Title - Sujet SAR Station Building Construction	
Solicitation No. - N° de l'invitation F1700-165107/A	Amendment No. - N° modif. 004
Client Reference No. - N° de référence du client F1700-165107	Date 2016-11-25
GETS Reference No. - N° de référence de SEAG PW-\$PWY-019-7908	
File No. - N° de dossier PWY-6-39208 (019)	CCC No./N° CCC - FMS No./N° VME
Solicitation Closes - L'invitation prend fin at - à 02:00 PM on - le 2016-12-02	
F.O.B. - F.A.B. Plant-Usine: <input type="checkbox"/> Destination: <input checked="" type="checkbox"/> Other-Autre: <input type="checkbox"/>	
Address Enquiries to: - Adresser toutes questions à: Ngan, Ken (PWY)	Buyer Id - Id de l'acheteur pwy019
Telephone No. - N° de téléphone (604) 658-2755 ()	FAX No. - N° de FAX (604) 775-6633
Destination - of Goods, Services, and Construction: Destination - des biens, services et construction: DFO - SAR Station - Campbell River, BC

This Solicitation Amendment 004 is raised to incorporate Addendum #2.

Project:	Campbell River SAR Station	Addendum No.:	A-M02
Project No.:	131-19106-05	Date:	November 24, 2016
Distribution:	Number 10 Architectural Group - Rob Halliday

A 7.02 detail 7a & 7b

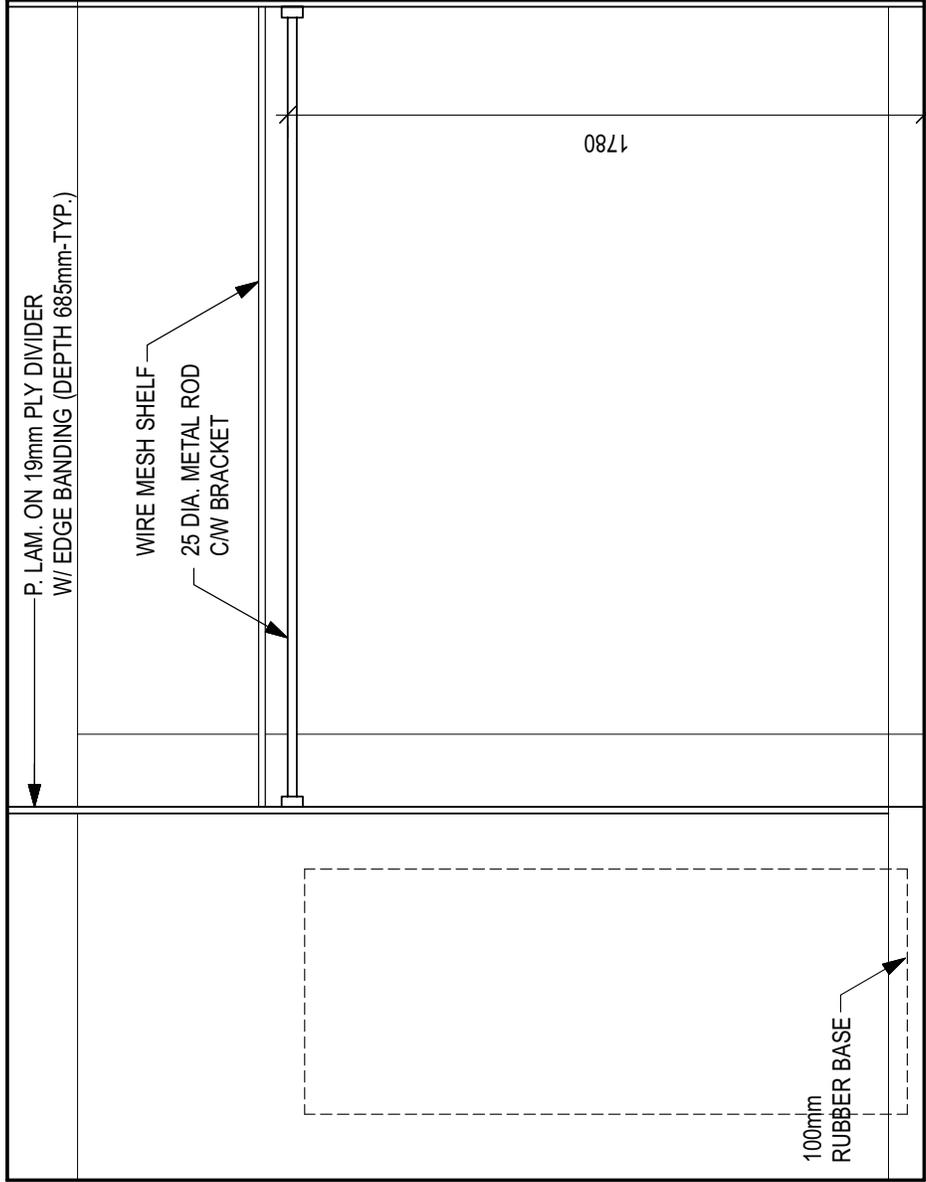
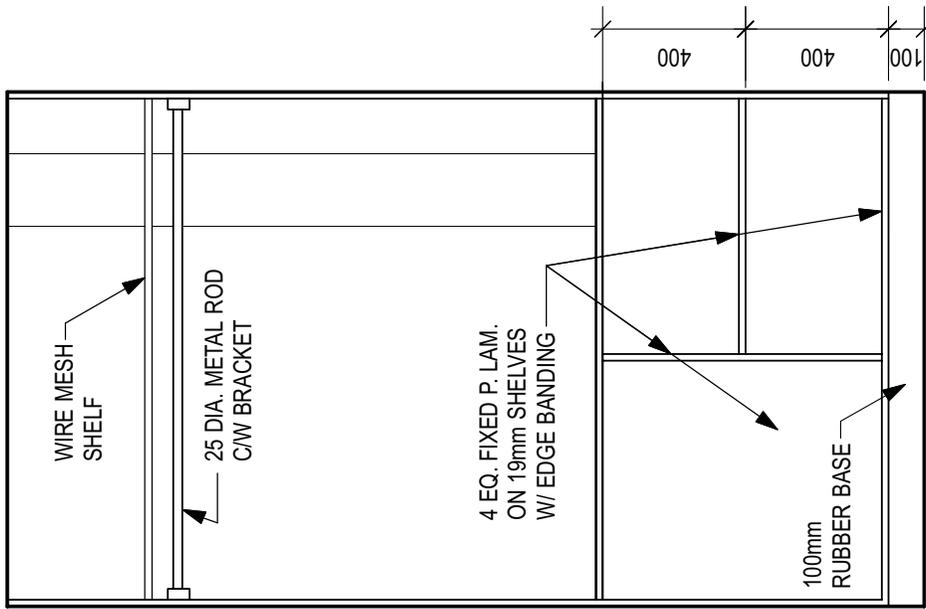
See attached revised elevations indicating the two rod and shelving conditions occurring in the room 112 gear storage. Secure Storage room 113 rod and shelf to match detail 7b.

7a GEAR STORAGE SHELVES

7b GEAR STORAGE SHELVES
